Issue to resolve

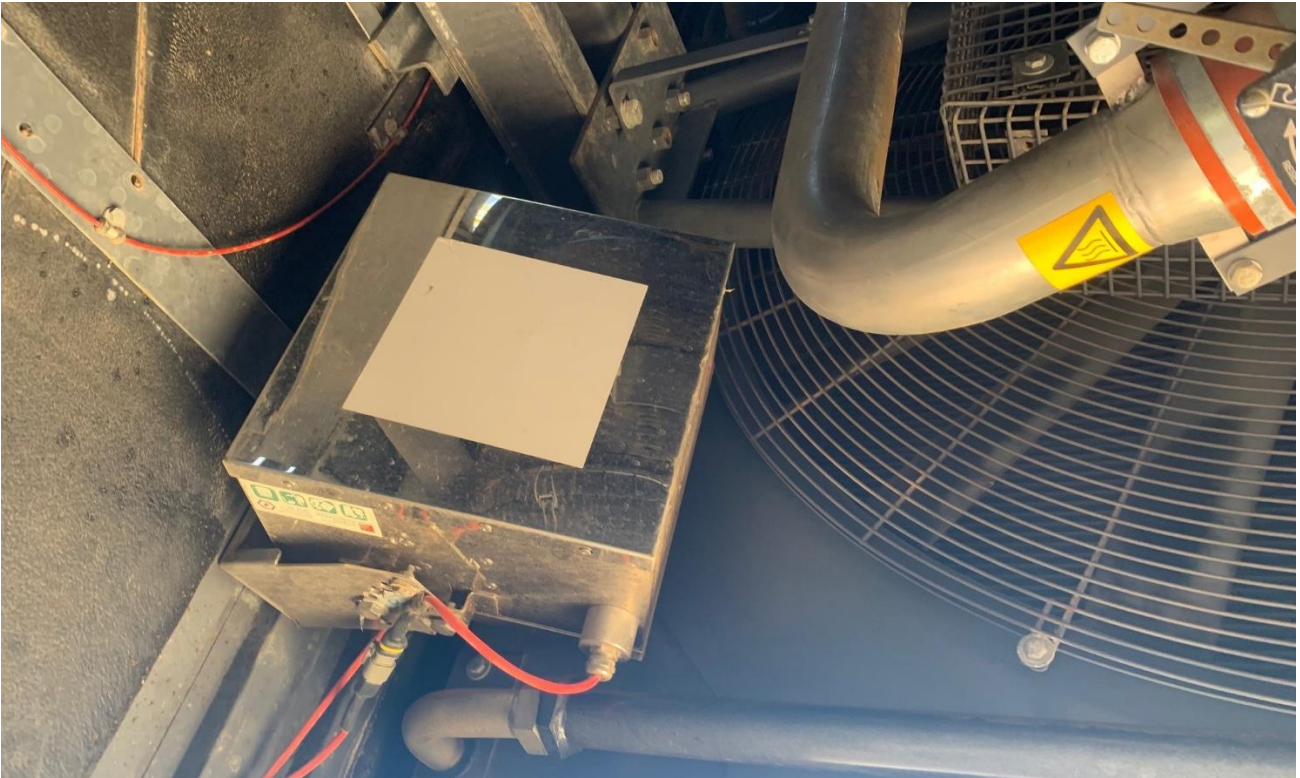
- Resolve mounting location for FP Unit – not as per drawing
- Resolve Mounting Location for Panel – not as per drawing
- Plastic Cover over Control Panel
